LOGOS Kemps Creek Logistics Project Preferred Project Report

October 2011

PJEP Ref: Preferred Project Report_Oct11

Figure 2.2: Integrated Water Cycle Management Strategy Schematic (Source: Aquacell)

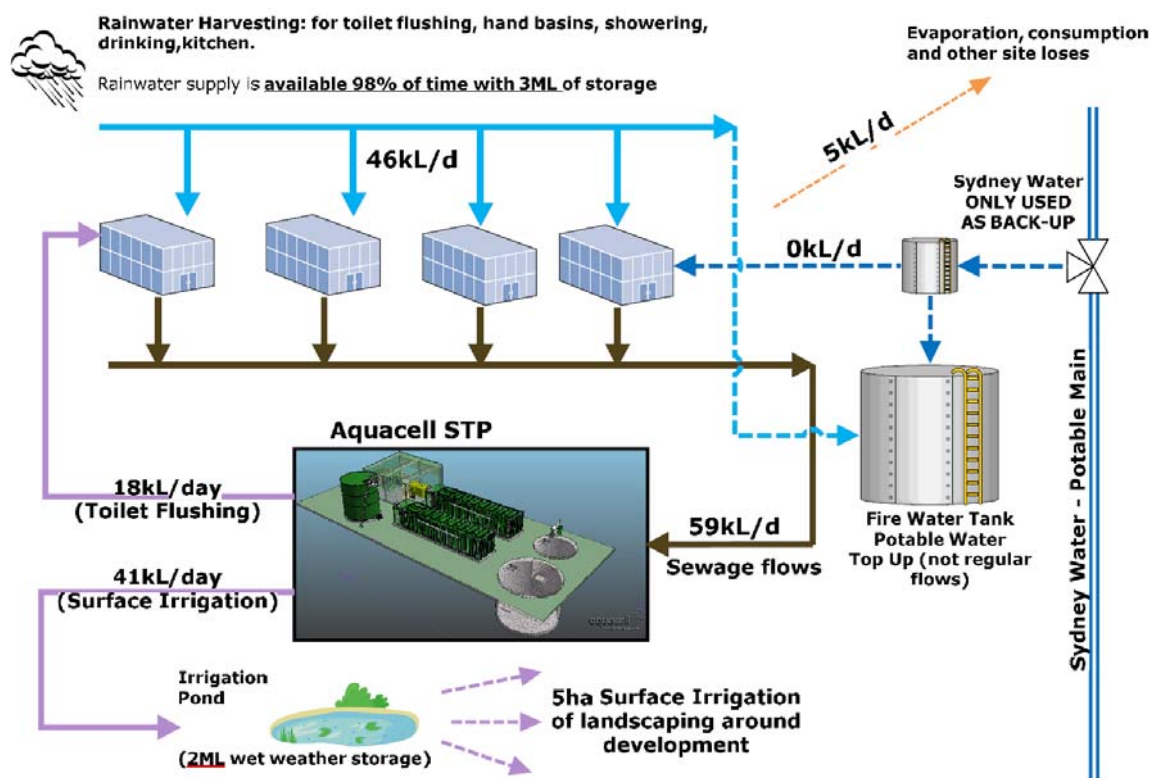
- rainwater harvesting from warehouse roofs, with the water treated and used for potable water demands (including drinking);
- on-site sewerage recycling, with the recycled water used for irrigation and toilet flushing; and
- integrated stormwater management based on Water Sensitive Urban Design (WSUD) principles.

LOGOS has prepared an Integrated Water Cycle Management Strategy which describes and assesses the proposed strategy, attached as **Appendix D**. A summary of the proposed strategy is provided below, and a schematic illustrating the key processes is shown on **Figure 2.2**. Consideration of the environmental effects associated with the strategy is provided in Section 3.

Figure 2.3: Revised Sewer Servicing Strategy (Source: Buckton Lysenko)

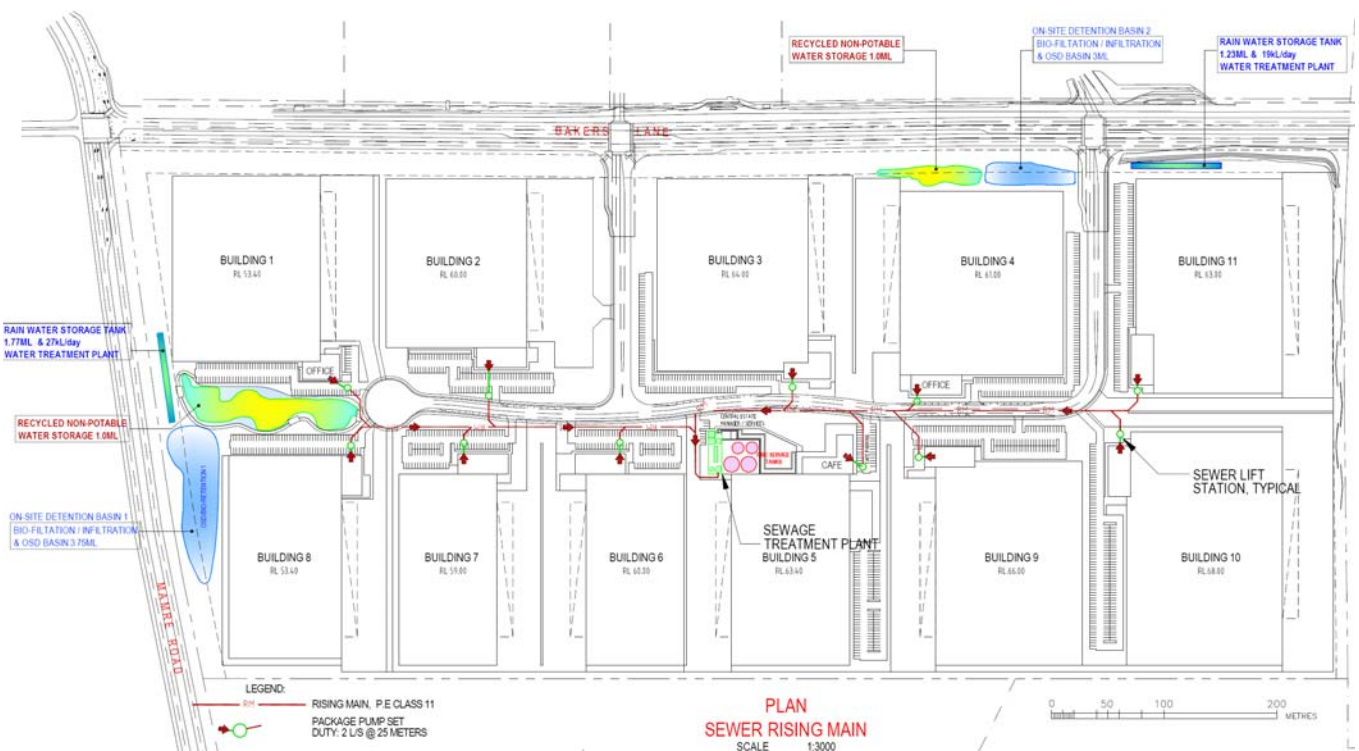
The proposed sewer servicing strategy for the project is shown on **Figure 2.3** below, and essentially involves on-site recycling of all sewerage generated by the project, with recycled water used for on-site non-potable uses (ie. toilet flushing and irrigation).

- wastewater generated on site (ie. approximately 59kL/day) would be pumped to a centrally-located sewage treatment and recycling plant;
- wastewater would be treated to a high quality² in the treatment plant, with the treatment train including:
 - mechanical screening to remove solids:
 - generating between 20-50L of compacted washed screenings (solids) a week, which would be stored in a hygienic and closed bagging system;

- recycled water would be piped to warehouses for non-potable water use (ie. toilet flushing), or irrigated in landscaping areas of the site; and
- excess recycled water (ie. during wet weather when irrigation is unavailable) would be stored in 2 wet weather recycled water storages located in the eastern area (1 ML storage) and western area (1 ML storage) of the site, prior to on-site irrigation. Water balance modelling indicates that a total storage volume of 2 ML would ensure that discharge from the storages would not occur more frequently than 1 in 2 years³. Any overflows would be directed to the adjacent bio-filtration and on-site detention basins, prior to discharge from the site via the stormwater management system.

Figure 2.4: Revised Potable (and Non-Potable) Water Servicing Strategy (Source: Buckton Lysenko)

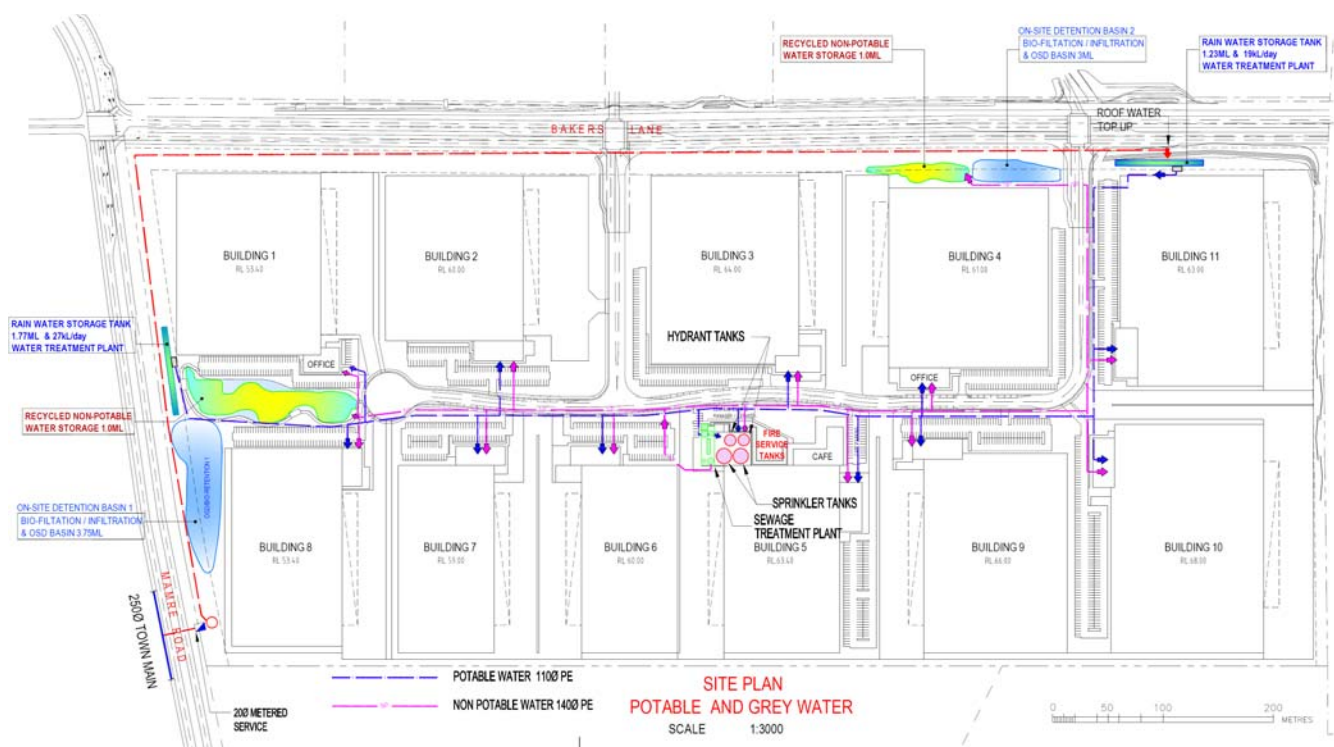
The proposed potable water servicing strategy for the project is shown on **Figure 2.4** below.

- harvesting of rainwater from the full roof area of each warehouse;
- collected rainwater would be stored in 2 rainwater storage tanks located in the eastern area (1.23 ML tank) and western area (1.77 ML tank) of the site. The tanks would be of concrete construction, and predominately buried below ground (the top approximately 1 metre of the tank would be located above ground, with this visible portion landscaped to mitigate any adverse visual impacts – see Section 3). Water balance modelling indicates that a total tank storage volume of 3 ML would satisfy the project's potable water demands for 98% of the time;

- stored rainwater would be treated before use using ultra-filtration and UV disinfection (or similar) to meet Australian Drinking Water Guidelines, then pumped to warehouses for potable water use (including drinking, washing and showering, cleaning, and firewater supply); and

- overflow from the rainwater storage tanks would be directed to the adjacent bio-filtration and on-site detention basins, prior to discharge from the site via the stormwater management system.
